802.1aj Two-Port MAC Relay Editor's report

John Messenger, November 2008

Figure K-2—TPMRs with aggregated links

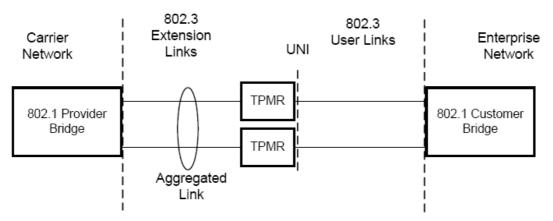
- Use case K.2 shows two TPMRs in LAG links. This conflicts with the addresses in table 8-3.
- Comments
 - Stephen Haddock #16
